Our ref: L.A11940.003.002_RFI_Response.docx

17 December 2024

RE: Responses to Lake Macquarie City Council's RFI comments

This document forms an addendum to BMT's Concept development application and first stage of development (65 Glendale Road, Glendale) Flood Impact Assessment Report (R.A11940.001.04_GlendaleFIA). A request for information (RFI) was received from Lake Macquarie City Council in response to the development application and this document seeks to respond to the flooding related RFIs.

Figure 1.1 Comparison of ARR1987 and ARR2019 Design Rainfall Data

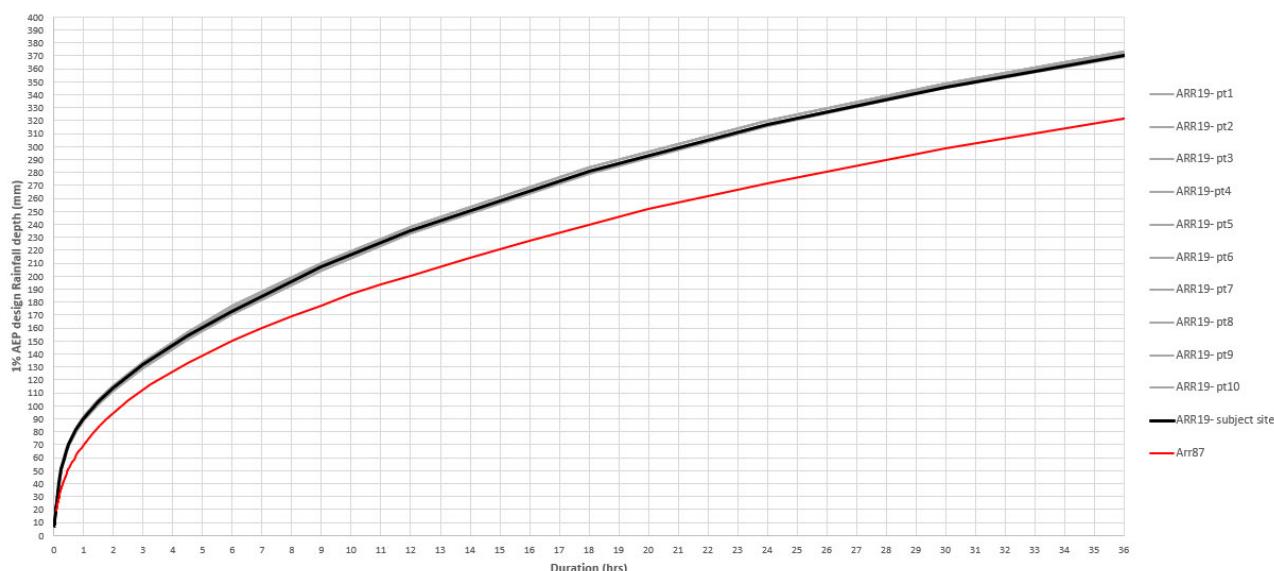
In adopting the 2015 flood model, the FIA uses 1987 ARR rainfall data to develop the hydrology model. The more current 2019 ARR rainfall data shall be used to ensure accuracy.

Council's adopted flood study uses ARR1987, the approach used in this study is consistent. Evidence has been provided to support BMT's position that an update to ARR2019 methodology was not needed, which has been agreed and accepted by Council (refer to email correspondences attached in Annex B).

An analysis of design rainfall data was conducted for the site (black curve in Figure 1.1) and for 10 scattered locations across the Winding Creek catchment (grey curves in Figure 1.1). The findings are as follows:

- The ARR2019 IFD curves demonstrate negligible spatial variability across the catchment. This is expected due to the relatively small extension of the catchment (~25 km²).
- ARR2019 rainfall depths are approximately 15% higher than those used in the original flood study (red curve in Figure 1.1) developed with ARR1987 methodologies.

Figure 1.5 Stormwater pipes and swale at the Site on Lot 1 for Developed scenario

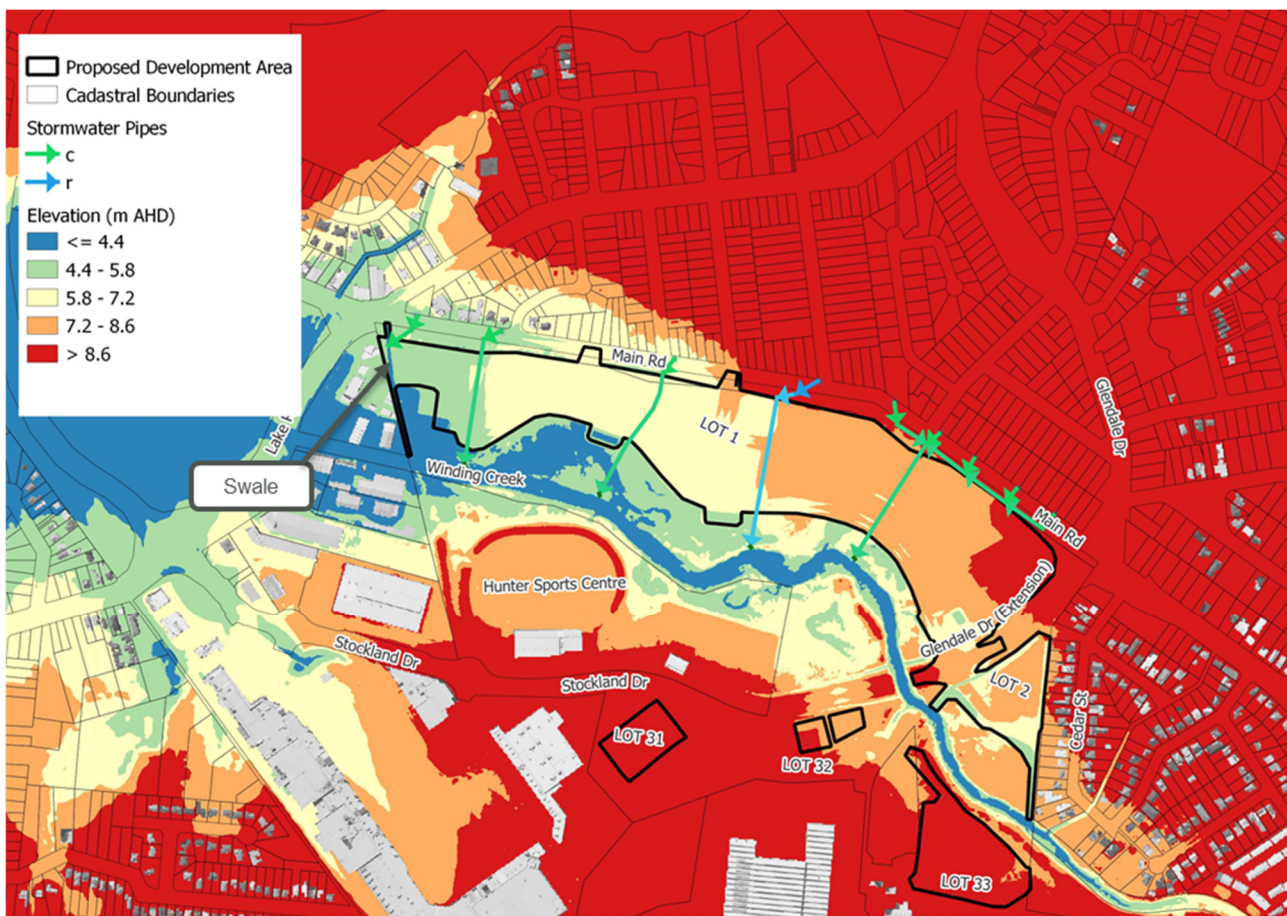
The FIA appears to have disregarded overland flow in the post development scenario when setting the FPL for lot 1. It proposes that inter-allotment drainage will be incorporated into the development to manage overland flows through this area.

Pits and pipes become blocked during flood events and cannot be relied upon to manage flood flows (drainage pipes typically only account for the 10% AEP).

There will be a direct impact to flooding of Main Road which is a Transport for NSW (TfNSW) asset. TfNSW requirements for increased impact on their assets are low and shall be confirmed with the TfNSW if they are willing to accept any increased flood in this instance.

Overland flows were included, no local drainage was included. Modelling has been updated to include major swales designed to convey flows from north to south across Lot 1. Pits and pipes (minor drainage) are assumed to be blocked during a major event. Please see response to comment 2.8 for details about modelling updates.

- Included proposed stormwater bypass swales and proposed major stormwater pipes to convey flows from north to south across Lot 1 (Figure 1.5).
- Local stormwater network was assumed to be completely blocked during major storm events and was not included in the model
- Water entry into Lot 1 was prevented in the flood model by implementing thin walls (TUFLOW 2d zsh layer) along the northern site boundary and internal lot boundaries. This approach ensures the overland flow goes where intended and can inform updates to the proposed design during subsequent project stages based on flood modelling results (such as by incorporating increased fill level, localised bunds, swales, or similar).
